**Preliminary detailed assessment of  
gaseous and liquid discharges of  
radioactive waste for General Nuclear  
System Limited's UK HPR1000 design -  
AR04**

This report covers our Generic Design Assessment (GDA) of General Nuclear System Limited's (GNSL's) submission on gaseous and liquid discharges of radioactive waste for the United Kingdom Hualong Pressurised Reactor design (UK HPR1000) as required in Table 1, Item 5 of our Process and Information Document (P&ID) (Environment Agency, 2016).

Gaseous - Hydrogen-3 - comparison of discharges and limits

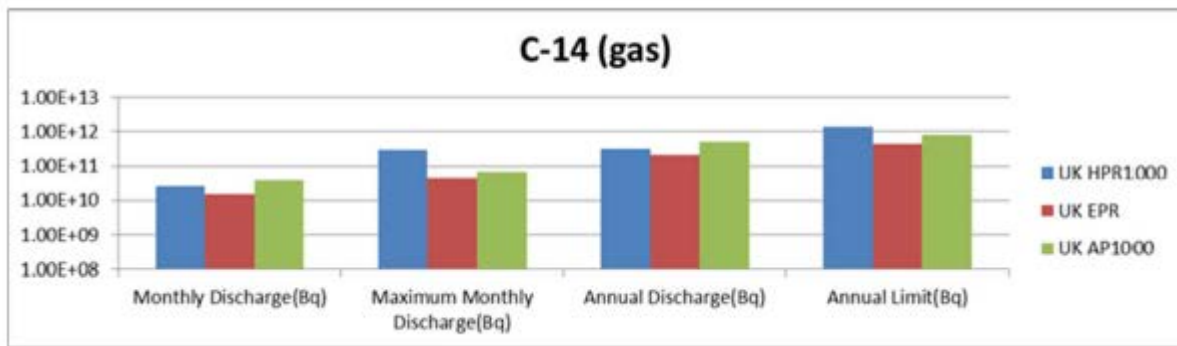
The graphs show that for all radionuclides, except gaseous hydrogen-3, carbon-14 and liquid hydrogen-3 the UK HPR1000's discharges are the same or slightly lower than the other PWRs.

Where the UK HPR1000 discharges are slightly higher (gaseous hydrogen-3, carbon-14 and liquid hydrogen-3), GNSL has explained that this is likely to be due to the varying assumptions made between the 3 GDAs. GNSL initially cited the different approaches as being specifically due to headroom factors and expected events. We considered that better justification was necessary and issued RQ-UKHPR1000-0843 to request this. The RQ remains open at the time of writing and we will assess the response when we receive it.

Gaseous - Hydrogen-3 - annual discharges

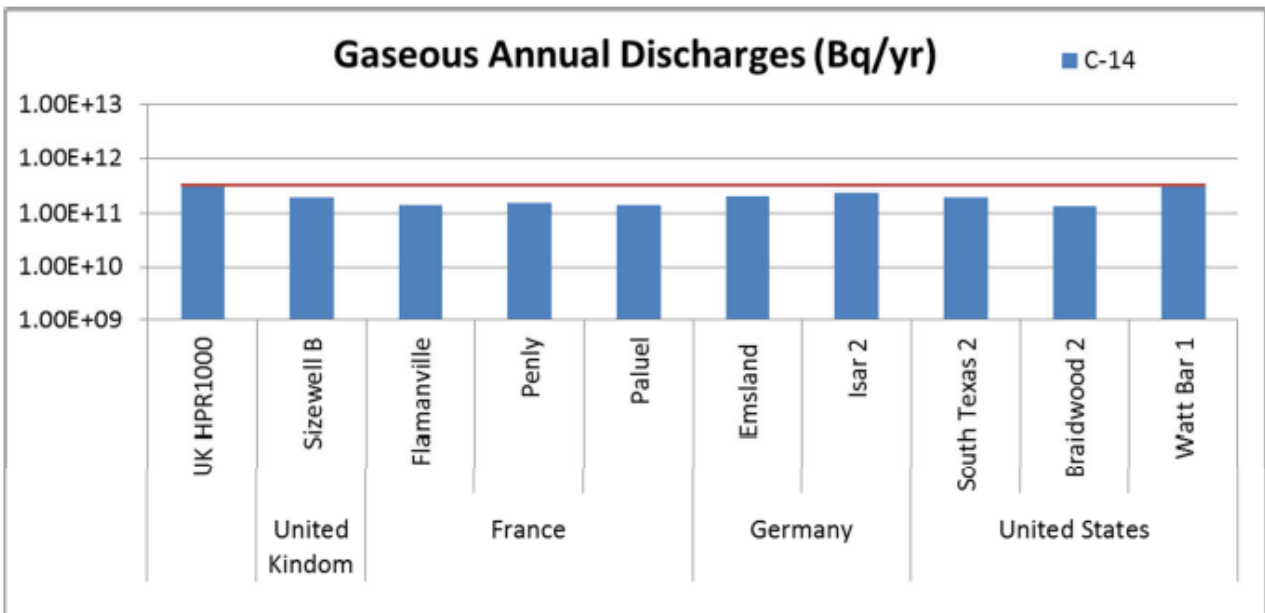
- Gaseous carbon-14 from the UK HPR1000 design is slightly higher than comparable plants that use hydrogen as the cover and purge gas.
- Gaseous discharges of hydrogen-3, noble gases, halogens and other radionuclides are generally comparable (higher than some, lower than others) to other plants. GNSL cites the likelihood that some UK HPR1000 figures could be overestimated (see 'GNSL considerations above).
- The liquid annual discharge of other radionuclides (which includes carbon-14) is slightly higher than comparable plants that use hydrogen as the cover and purge gas.
